West Midlands Interchange Proposed Non-Material Change Environmental Implications Report

West Midlands Rail Freight Interchange Order 2020 (as amended).

Four Ashes Limited
June 2023

Figure 3.3: Consented Green Infrastructure

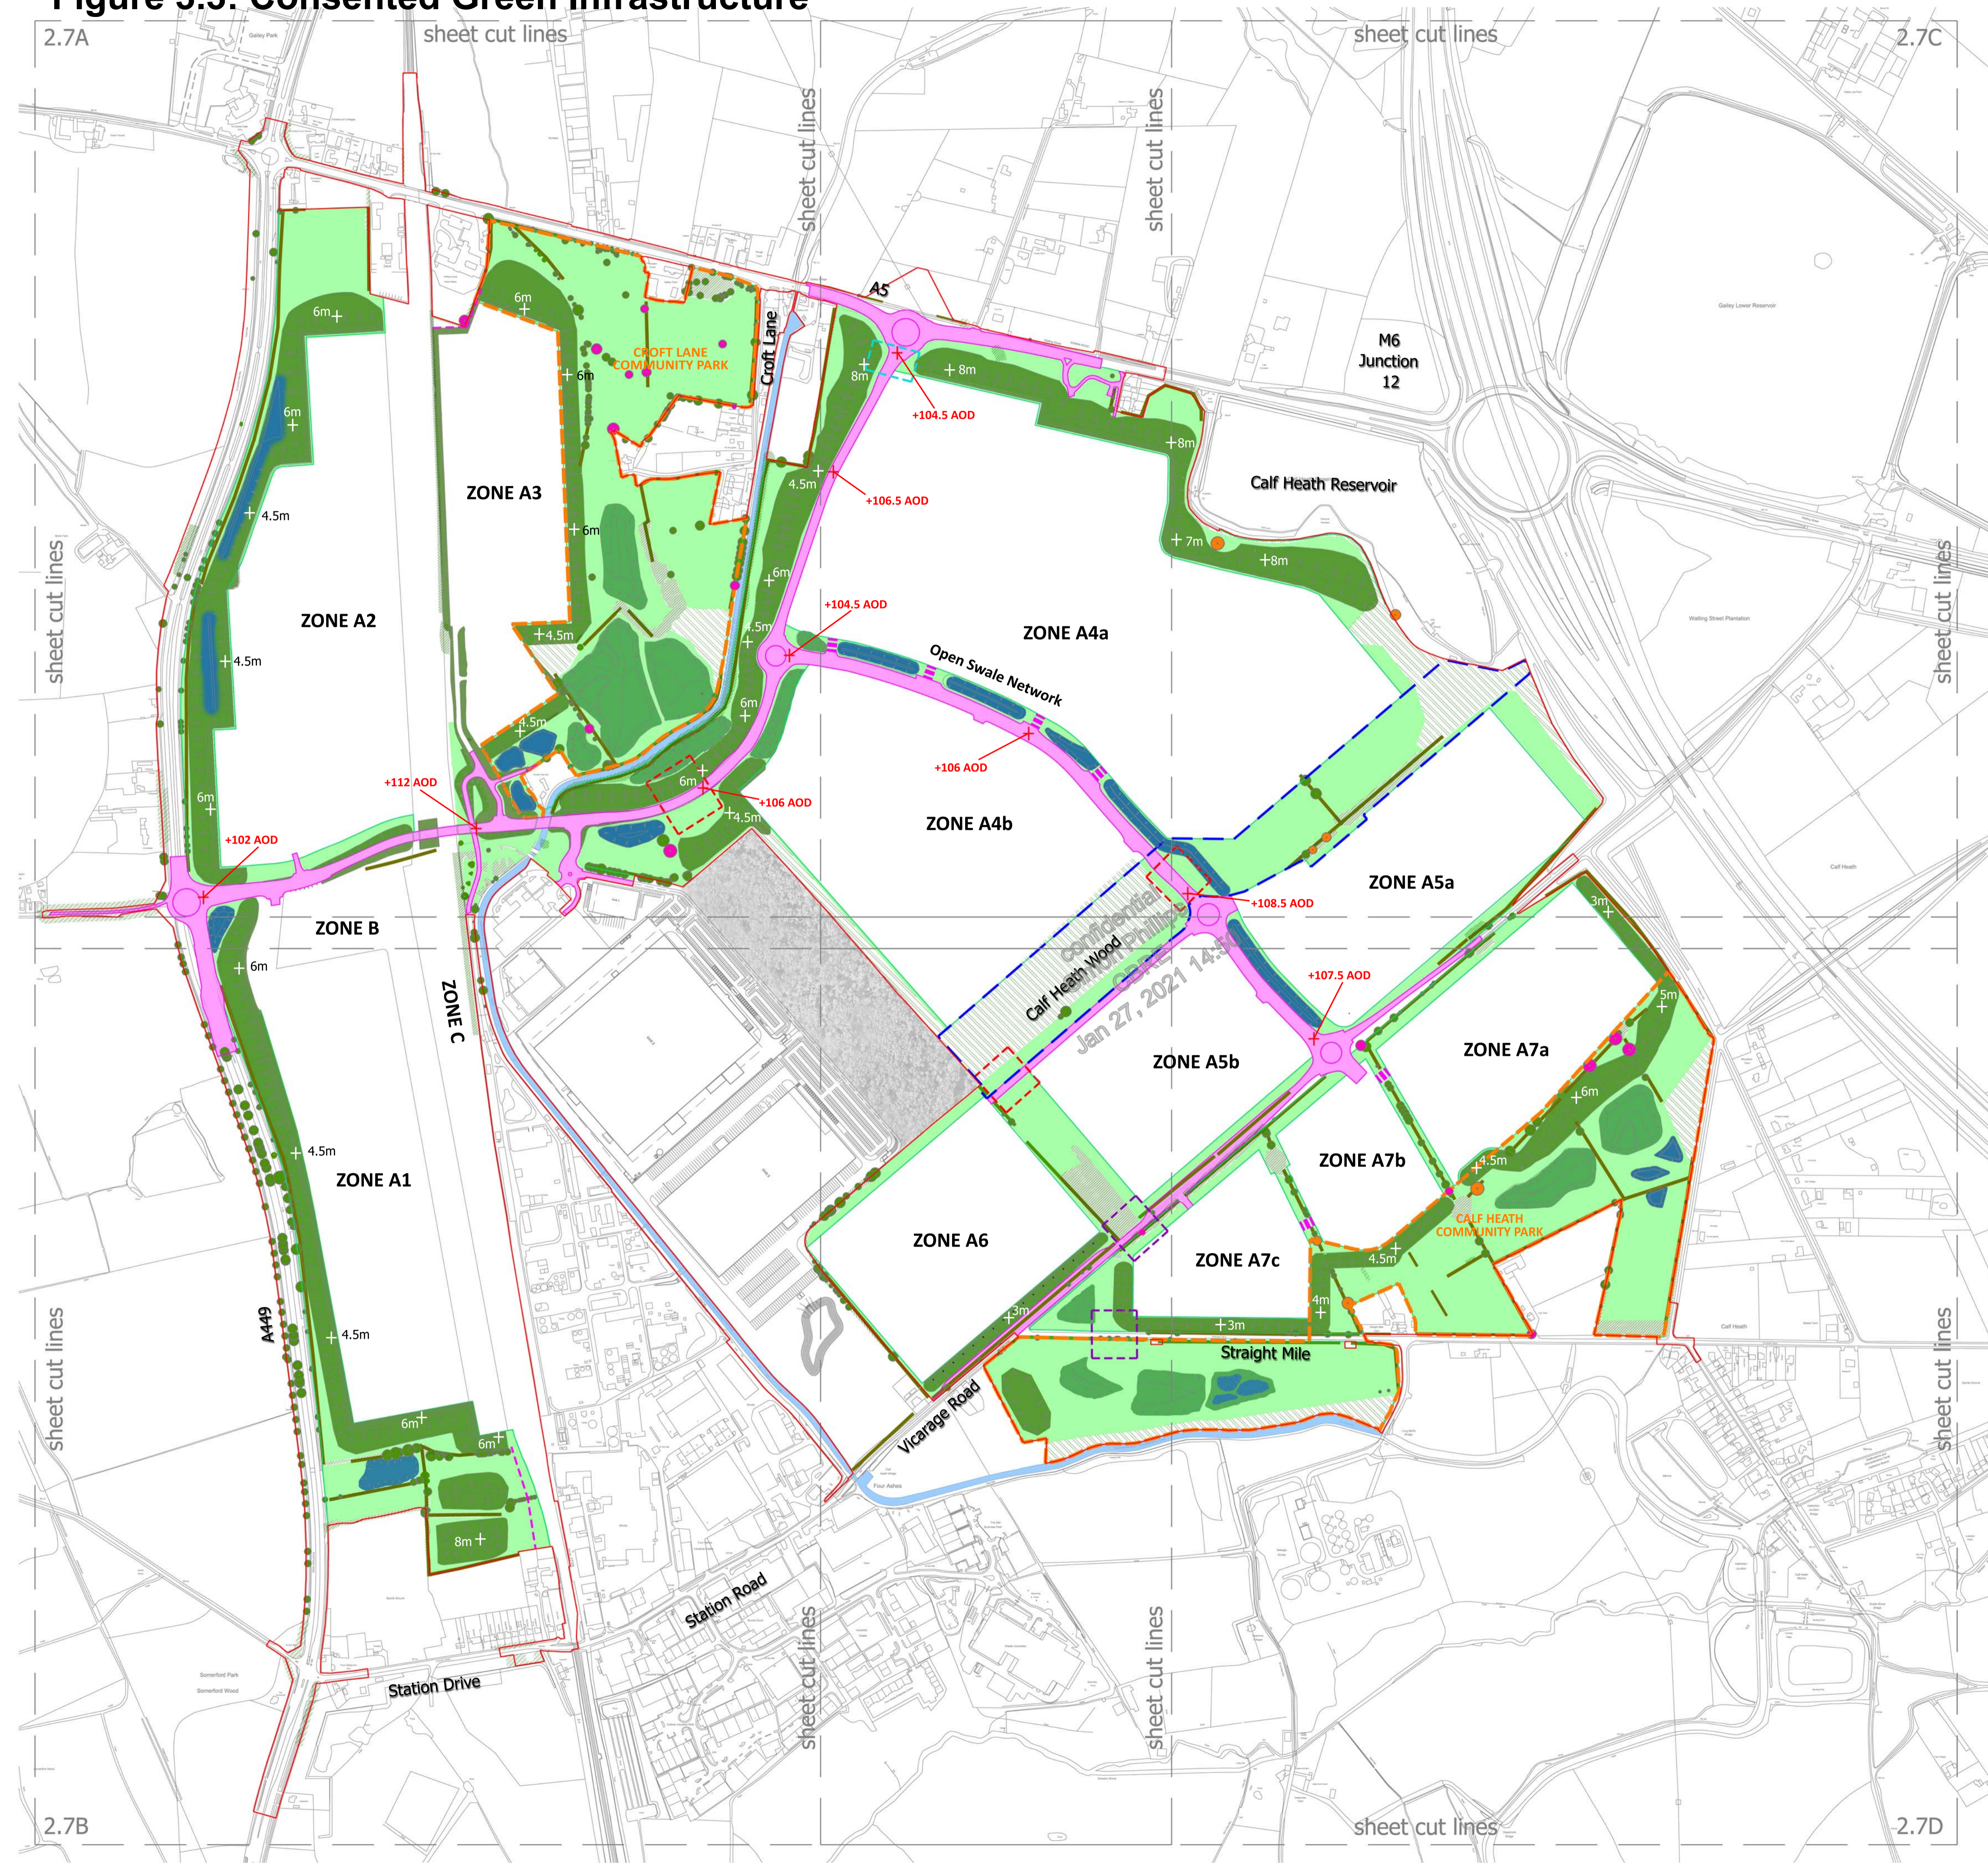
The proposed amendments to new on-site road infrastructure levels would comprise variations to the heights as compared with the approved spot levels by between circa. 0.9 metres below and circa. 1.2 metres above these spot heights. In order to provide flexibility, the 0.5 metre upward and downward limit of deviation, as currently provided for on the certified Parameter Plans and through Article 4(b) of the Order, would be retained. The approved and proposed spot height levels are shown in **Figures 3.3 and 3.4, Appendix A** and can be summarised as follows:

Figure 3.4: Proposed Green Infrastructure Plan

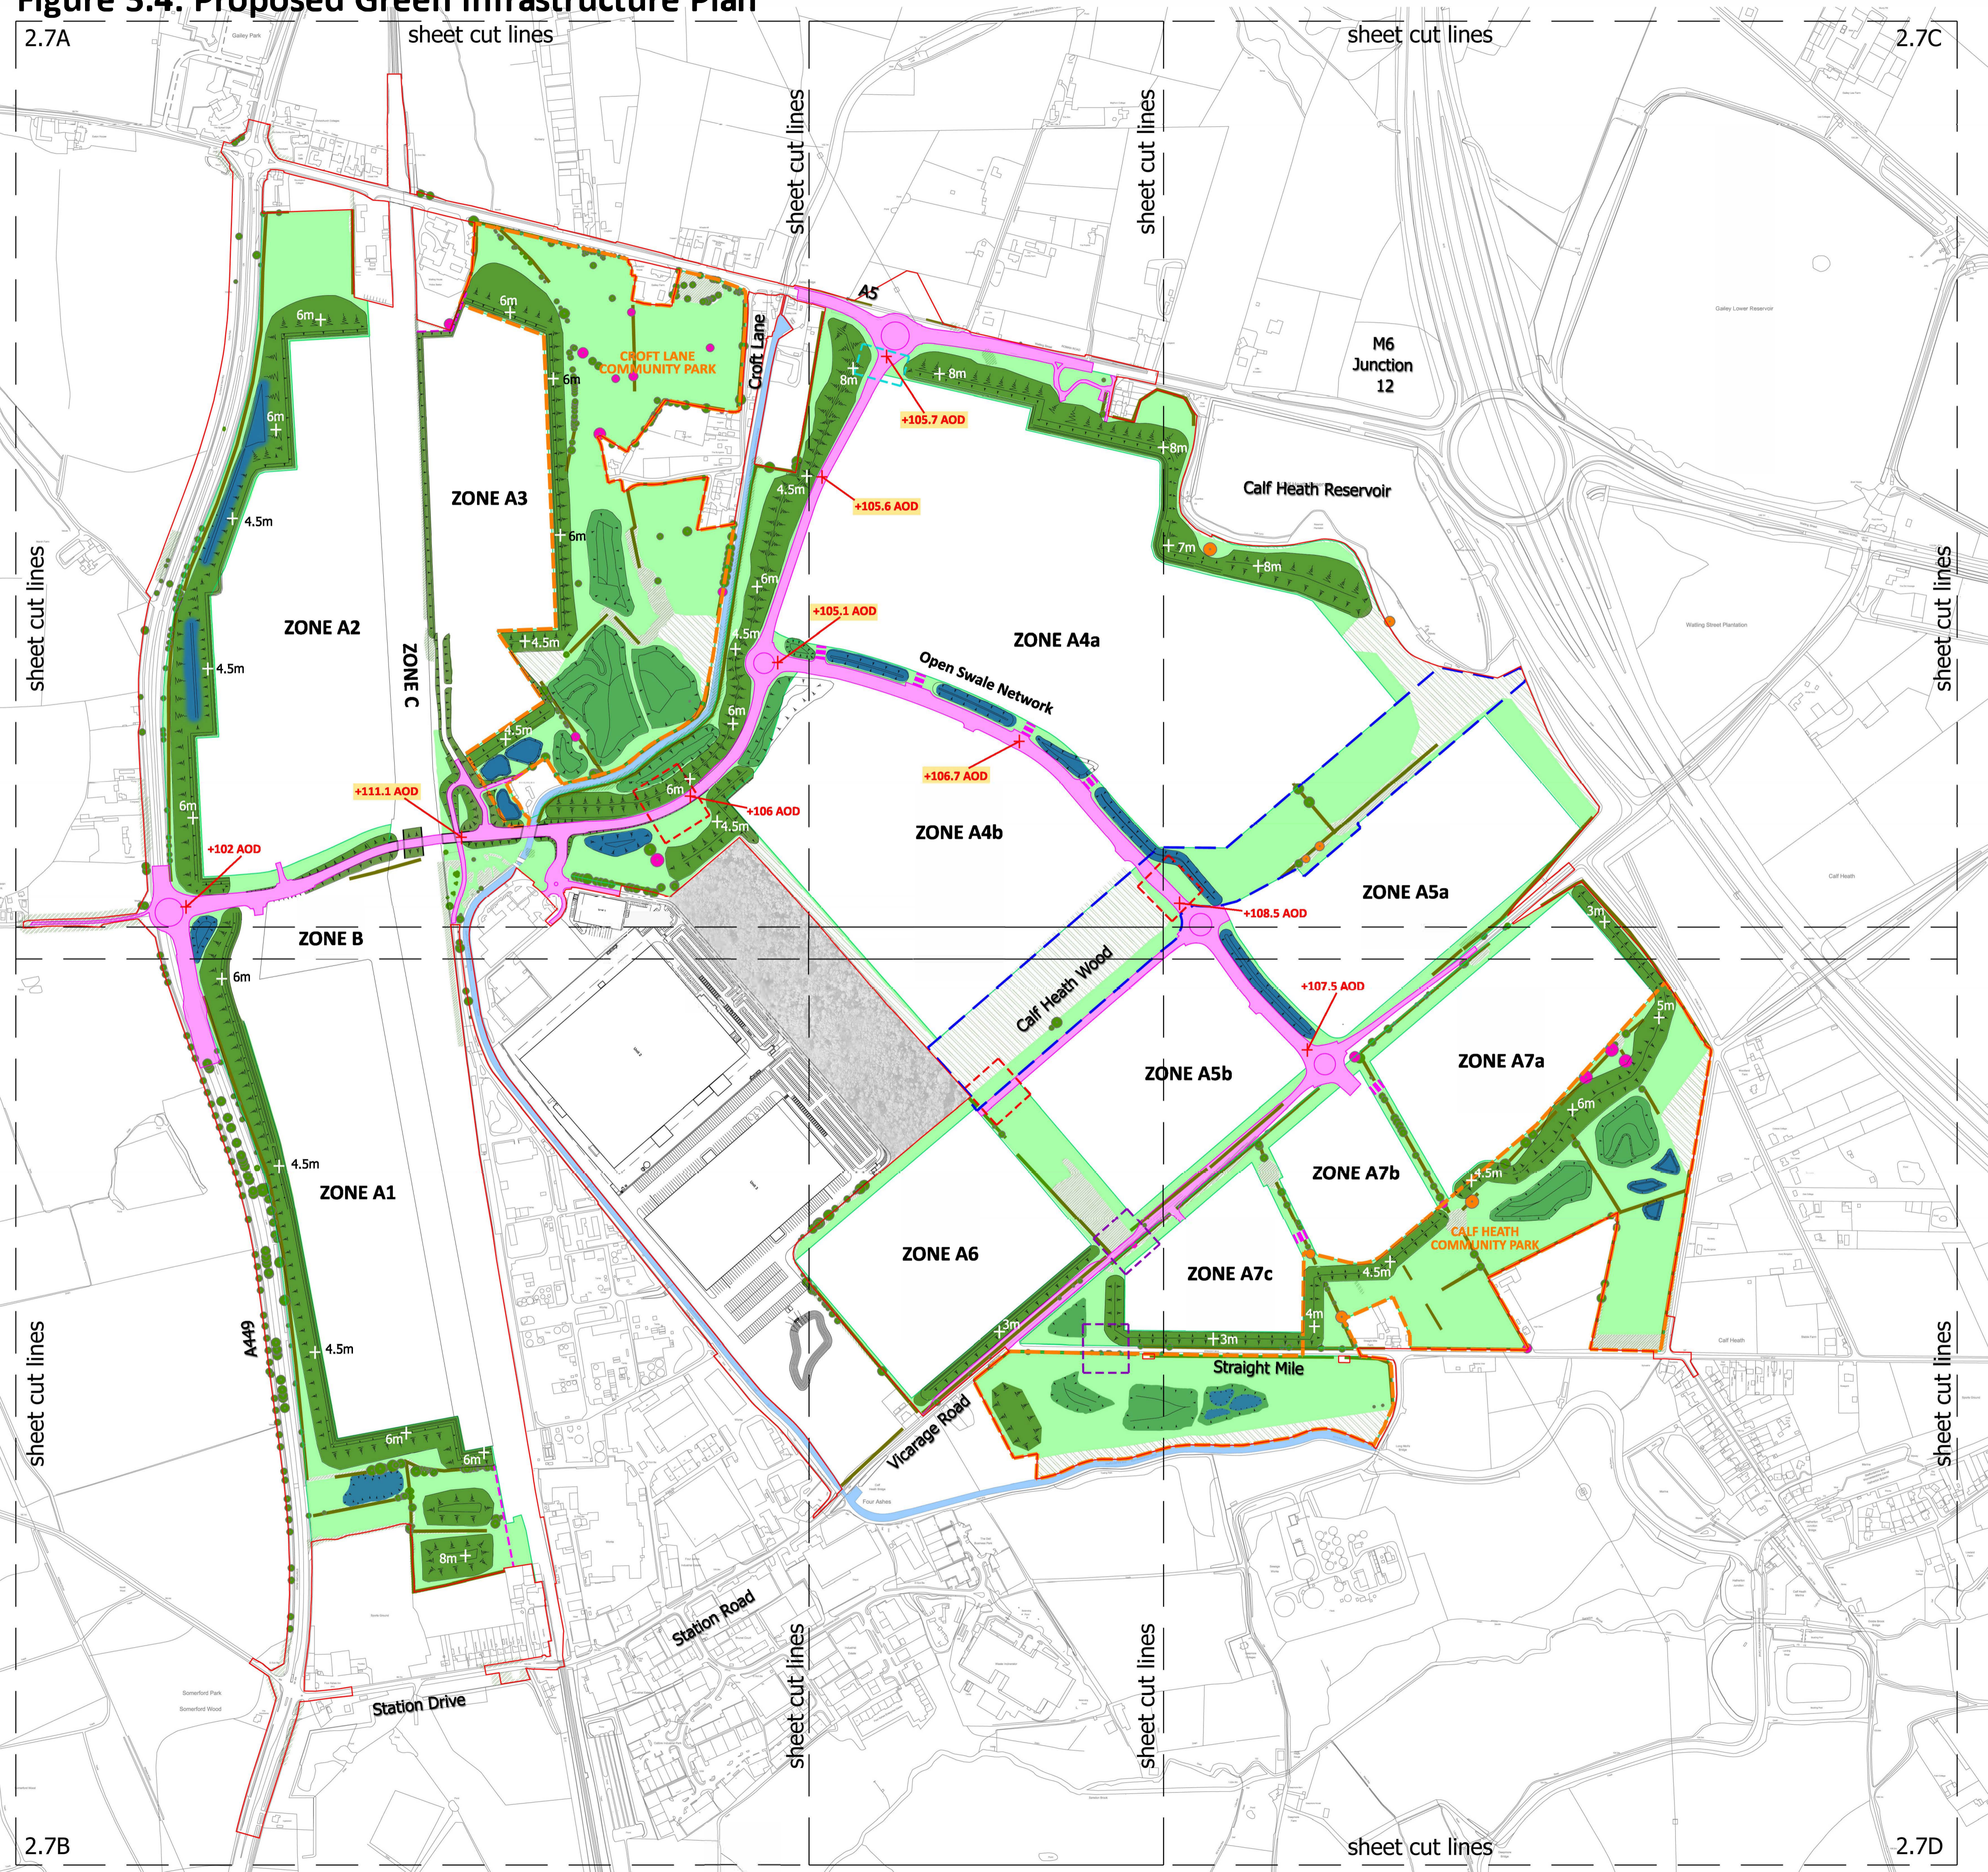
The indicative location of acoustic fencing identified on the certified Green Infrastructure Parameters Plan would be relocated westward, as shown in the revised Parameter Plan (**Figure 3.4, Appendix A**).
